Re: Comments of SCC Acquisitions, LLC to the Recirculated Draft
Environmental Impact Report/Supplemental Draft Environmental Impact
Statement on the San Diego Gas & Electric Company's Sunrise Powerlink
Project issued July 2008; Applications A.05-12-014 and A.06-08-010

**Sunrise Powerlink Transmission Line Project
Application No. 06-08-010
MGRA Comment on Recirculated Draft EIR**

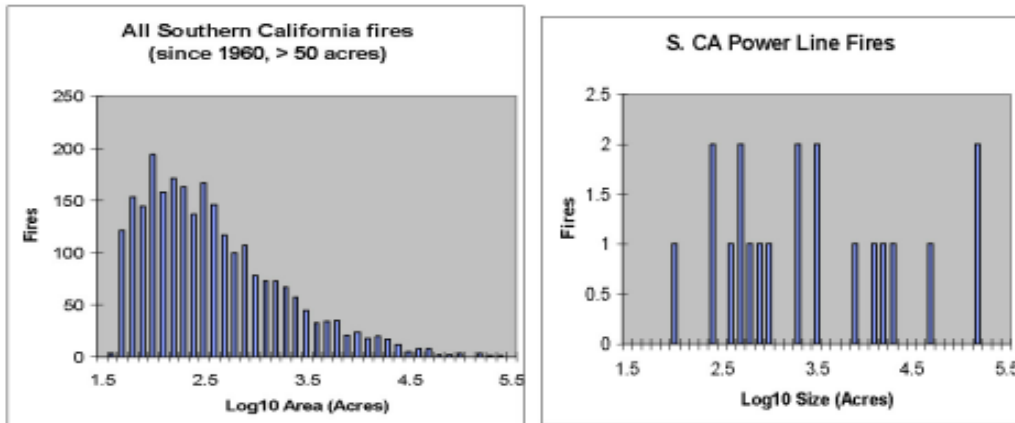
Restating our arguments: this is a very long line that goes through flammable vegetation for a considerable portion of its length, and which will be in place for a very long period of time. Additionally, **power line fires are *not* like other fires. Because they tend to start under high wind conditions, they statistically tend to be much larger than other fires.** While the size distribution of all wildland fires tends to drop off rapidly (as a power-law) with increasing fire size, the size of power line fires tends to be “logarithmically flat” – the probability of having a fire between 100 and 200 acres appears to be the same as having one between 100,000 and 200,000 acres¹². Now that the combined fire datasets for 2007 have been released by Cal Fire, we can show that **the data from 2007 continues to support this assertion, as shown in the graphs below:**

It is virtually impossible that the power line fires shown in the second graph arise from the same causal effects responsible for the shape of the first graph. It should be pointed out that fire professionals gauge their expectation for fire size probabilities on their historical observations – and these will be represented by graph on the left. This is one reason that some fire professionals, such as SDG&E’s fire expert, tend to downplay the power line wildland fire threat. Hence the comment that “few of these fires are large”

- G0013-6 Please see Responses to Comments G0013-1 and G0013-2.
- G0013-7 Please see Response to Comment G0013-2.
- G0013-8 Please see Response to Comment G0013-2.
